**ADDENDUM No. 1**

Date: January 27, 2015

Project Name: 3<sup>rd</sup> Street Reconstruction Phase 4 – Guadalupe St. to Nueces St.

C.I.P. No.: 8158.004

**3RD ST. RECONSTRUCTION  
 PHASE 4 - GUADALUPE ST. TO NUECES ST.  
 TRAFFIC CONTROL PLAN - RECONSTRUCTION  
 PHASE 7**

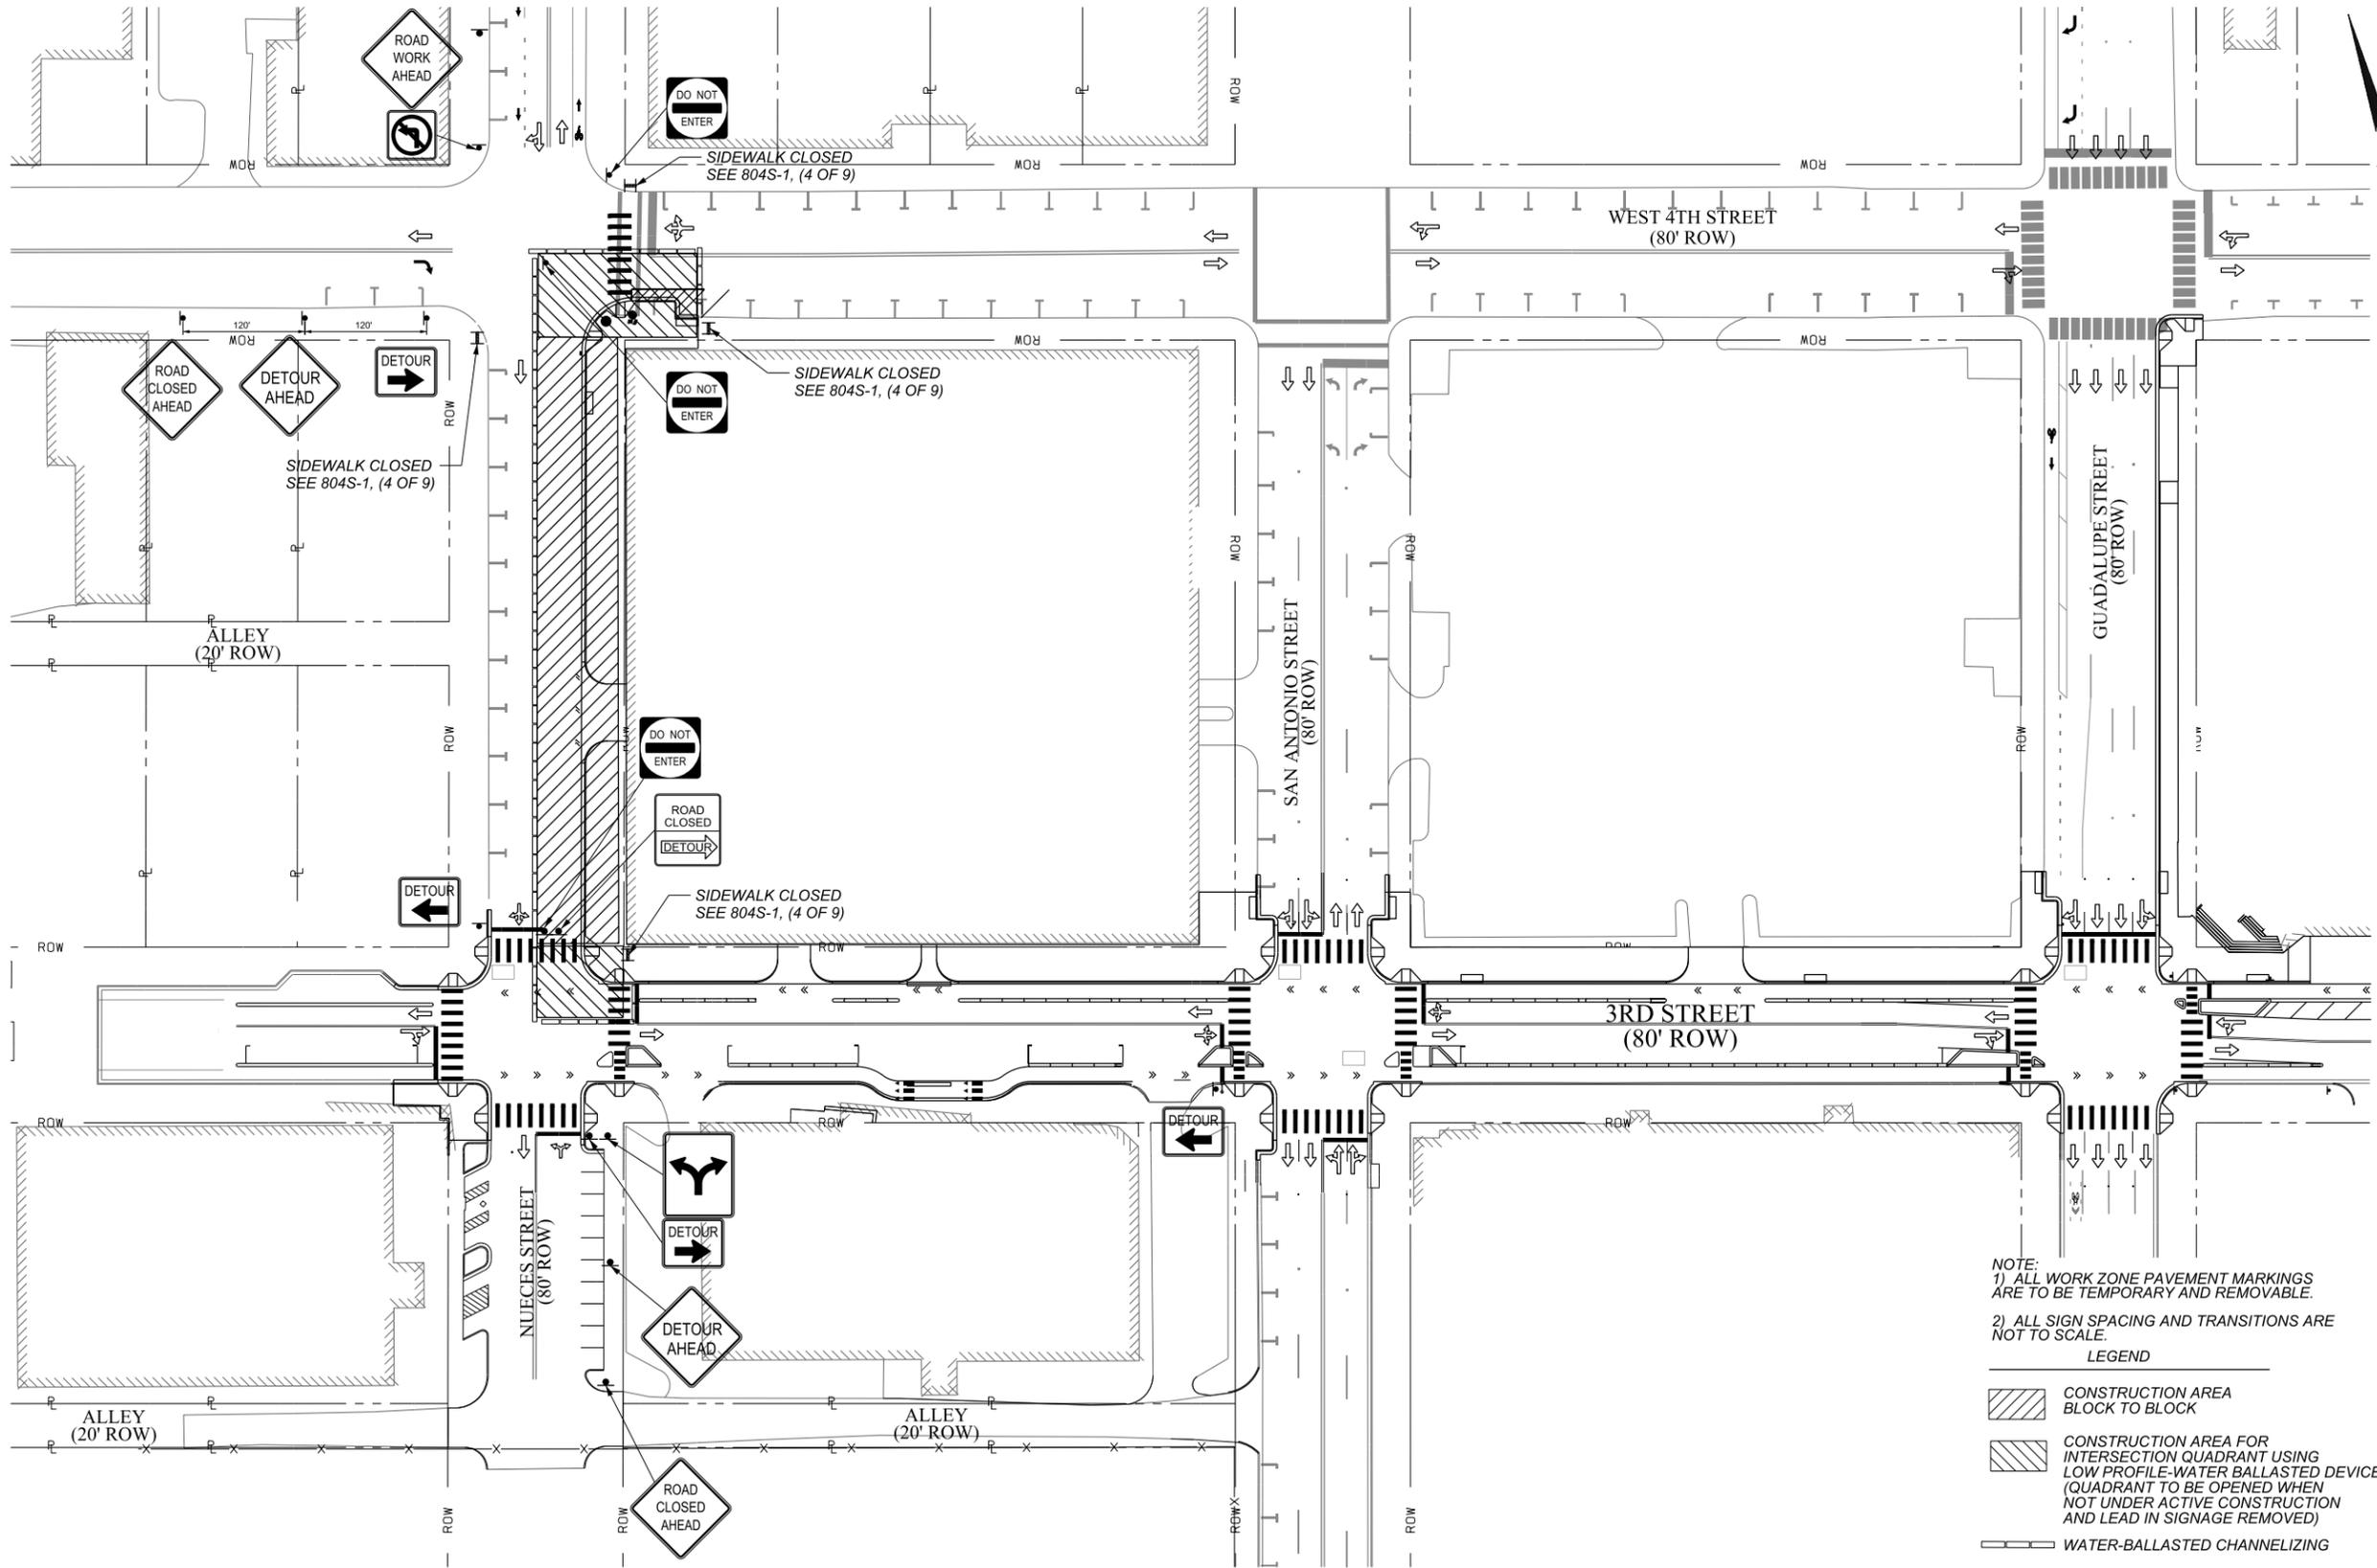
REV. NO.	DATE	REVISION DESCRIPTION
ADD FR	01/27/15	ADDENDUM 1: TITLE CHANGE
